**TO:** WECC ATSM ADHOC GROUP  
**FROM:** POUYAN POURBEIK, PEACE®; [PPOURBEIK@PEACE-PLLC.COM](mailto:PPOURBEIK@PEACE-PLLC.COM)  
**SUBJECT:** PROPOSED CHANGES TO VHVDC1 FOR CREATING VHVDC2  
**DATE:** 4/17/23 (REVISED 5/10/23; 8/23/24; 8/13/25)  
**CC:** P. MITRA, EPRI

This revision 4 of the specifications for vhvdc2 incorporates slight modifications to the original memo based on decisions made during a group virtual meeting on 8/13/25 at 1 pm US Central Time. Attendees at that call were: Wei Du, PNNL; Ning Lin, PowerTech Labs; Parag Mitra, EPRI; Raul Perez, NextEra Energy; Pouyan Pourbeik, PEACE®; Quan Nguyen, PNNL; Jay Senthil, Siemens PTI, Ramin Vakili, GE Vernova; Song Wang, PGE; and Jamie Weber, PowerWorld

**Figure 1:** Proposed changes to include a remote bus point of measurement and control.

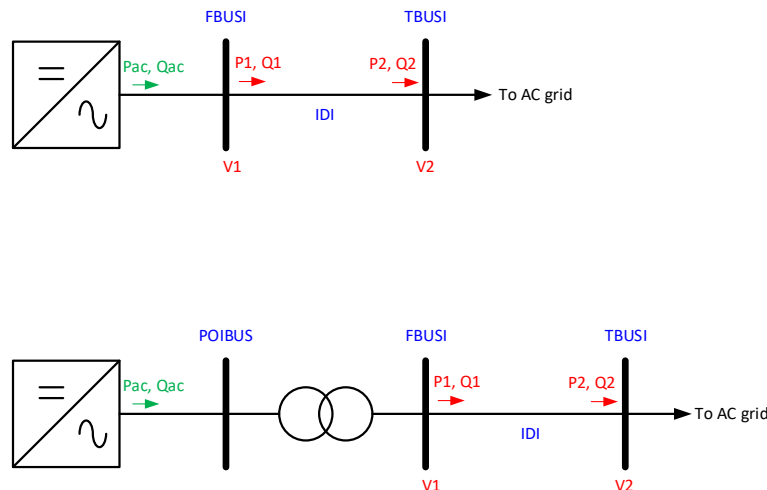
**Recommendation 1** – The key recommendation here was to allow for a remote bus in the power flow to be the point of measurement and control for each of the two converter stations. Thus, the decision was to introduce six (6) more parameters in the dynamic model, as follows:

The approach would be identical on both sides. Figure 1 below helps to explain the approach on the inverter side, with the rectifier side being the same.

As shown in Figure 1, one of two approaches can be taken. One to implicitly include the converter transformer in the loss calculations in the converter power flow model. Secondly, to explicitly model the converter transformer in power flow. It is extremely important to note that either way, the path from the converter to the most remote bus (TBUSI) must be completely radial. **Important Note:** A simple way that this can be checked in each software tool is that if  $P1$  (or  $P2$ )  $< 0.95 \times Pac$  then a warning message should be given to the user “*WARNING! Measured AC Power is significantly less than AC power coming out of the converter at bus XX, ensure that defined branch is radial to converter?*”. Also, if the defined branch is ill-defined (i.e., a nonexistent branch) then  $Pac$ ,  $Qac$  and  $Vac$  at the POI of the converter is used, and a warning message given to the user to this effect.

Above said, the following should be done assuming the defined branch is correct and radial:

- P and Q are always calculated in the direction of FBUSI  $\rightarrow$  TBUSI
- P1, Q1 and V1 are the measured values used in the model for P, Q and V ac control if TBUSI is a positive number
- P2, Q2 and V2 are the measured values used in the model for P, Q and V ac control if TBUSI is a negative number. (Note: the idea here is that when TBUSI is entered as a negative number, then clearly  $|TBUSI|$  is what is used in monitoring the branch, but the -ve sign indicates that the measurements are to be made on the TO end of the branch. Alternatively, an extra model parameter could be defined to indicate whether the FROM or TO end measurement points are to be used).

**Figure 2:** Proposed changes to the controller parts of the *vbvdc1* model.

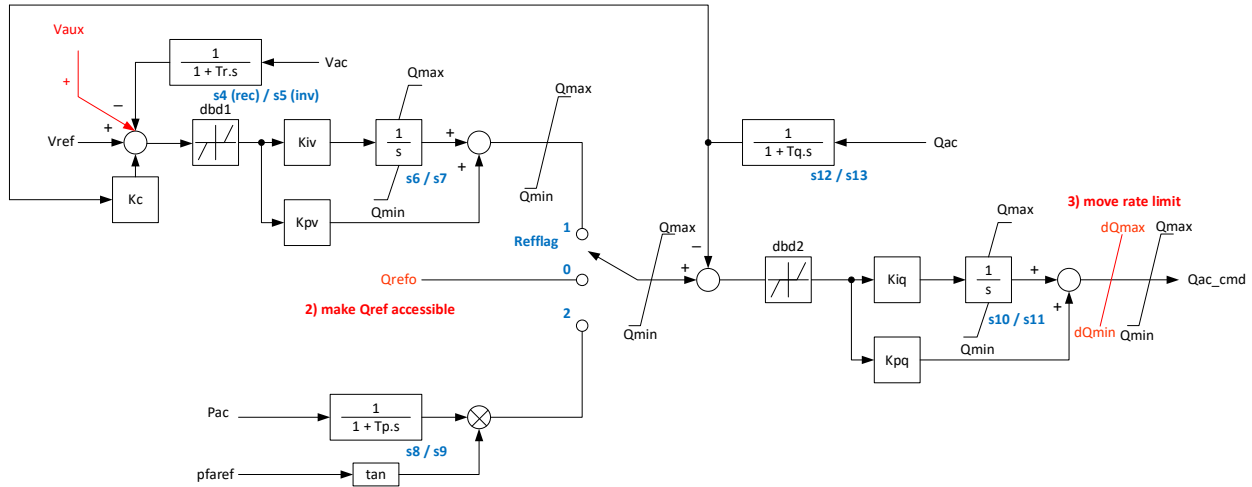
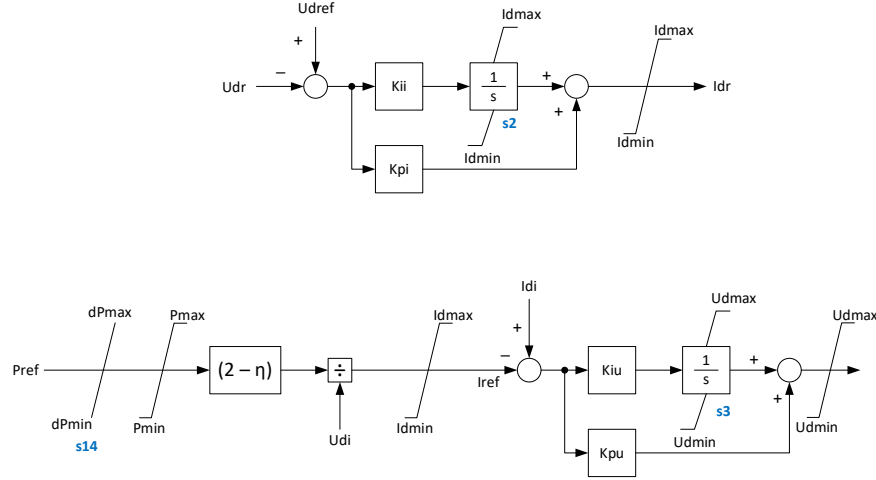
**Recommendation 2** – Add user access to *Qrefo* (see Figure 2 below). As an aside two other items were also discussed. First, to also add *Vaux* as an additional input accessible by the user. Secondly, to add another parameter to the dynamic model:

**Recommendation 3** – Move the ramp rate in the Q/V controls to the new location show in Figure 2 below. The software vendors indicated that they would implement this ramp rate as a numerically solved rate limit, rather than introducing a new state in the model with a very small time-constant.

**MVAbase AC** – if it is set to zero then *MWrate* is used for this value. If both this parameter and *MWrate* are set to zero, then an ERROR message is given to the user upon initialization and the simulation stops requesting the user to fix this.

Thus, *MWrate* (which is an existing parameter in vhwdc1) is used as the per unit base of all MW quantities, i.e., *Pmax*, *Pmin*, *dPmax*, *dPmin*, *Pref*, *p1*, *p2*, *p3*, and *p4*.

Thus, *MVAbase AC* is used as the per unit base of all MVar quantities and maximum ac current limit, i.e., *Imax*, *Kcr*, *Kci*, *dbd2r*, *dbd2i*, *Kpvr*, *Kivr*, *Kpqr*, *Kiqr*, *Kpvi*, *Kivi*, *Kpqi*, *Kiqi*, *dQmax*, *dQmin*, *Qref\_i*, *Qref\_r*, *Ipmax1*, *Ipmax2*, *Ipmax3*, *Ipmin1*, *Ipmin2*, *Ipmin3*, *Iqmax2*, *Iqmax3*, *Iqmin2* and *Iqmin3*.

**Figure 3:** Proposed V vs P lookup curve for determining the blocking voltage at the inverter/rectifier end as a function of active power (MW) transfer.

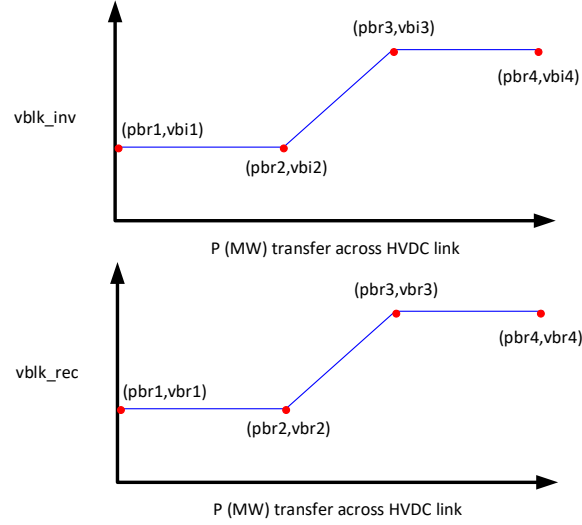
**Recommendation 4** – Add new parameters to define a look-up table for changing the blocking voltage at the inverter/rectifier as a function of active power (MW) being transferred by the HVDC link (see Figure 3).

Thus, *vblk\_inv* and *vblk\_rec* are removed as user input parameters from the dynamic model, and instead we introduce the following parameters, i.e.

- The power points must be monotonic, i.e.,  $1 \geq pbr4 > pbr3 > pbr2 > pbr1 \geq 0$
- If  $pbr4 < 1$ , then  $vblk_* = vb*4$  for all power levels above  $pbr4$
- If  $pbr1 > 0$ , then  $vblk_* = vb*1$  for all power levels below  $pbr1$ , down to 0 pu power
- The above three relationships apply to the both the inverter and rectifier side parameters.
- The voltage here refers to the voltage at the AC bus which is the point of measurement (POM) for the converter. That is, each converter side will block independently when the filtered Vac at the POM (e.g., voltage at V1 or V2, see recommendation 1) falls below the *vblk* coming out of this function.
- The value of P used on the x-axis of the four (4) point piecewise linear curves is the initial DC power transfer across the HVDC link upon model initialization on the rectifier side.
